Swan and Canning Rivers Management Act 2006

DETERMINATION OF DEVELOPMENT APPLICATION

FILE NUMBER	:	2020/2581
APPLICANT	:	Public Transport Authority
APPLICANT'S ADDRESS	:	PO Box 8125, Perth Business Centre, Perth
LANDOWNER	:	Department of Biodiversity, Conservation and Attractions
LAND DESCRIPTION	:	Mends Street Jetty, Lot 301 on Deposited Plan 47451 (Swan River), Mends Street, South Perth
DEVELOPMENT	:	Upgrade of the Mends Street Jetty comprising an extension of the existing jetty, installation of an accessible pedestrian boarding ramp and associated floating boarding platform and the provision of a sheltered waiting area for passengers
VALID FORM 1 RECEIVED	:	4 November 2020
DETERMINATION	:	APPROVAL WITH CONDITIONS

Mends Street Jetty Additions

3. Widening the pinch point past Mr Walker

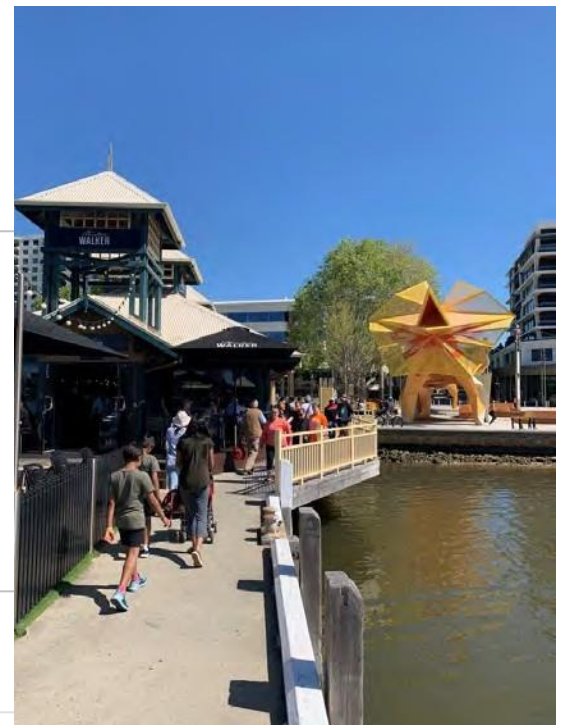
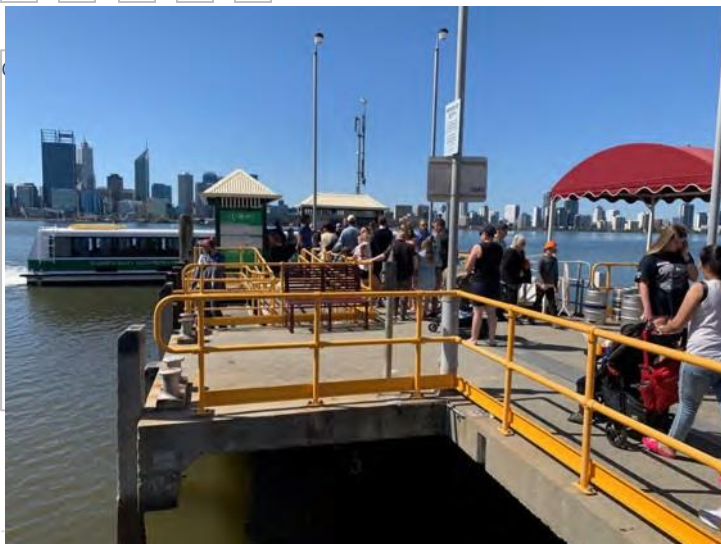
While compliant with standards, the walkway past Mr Walker provides a pinch point and does not encourage ease of use of the jetty (see attached image). This could be greatly improved by widening this area.
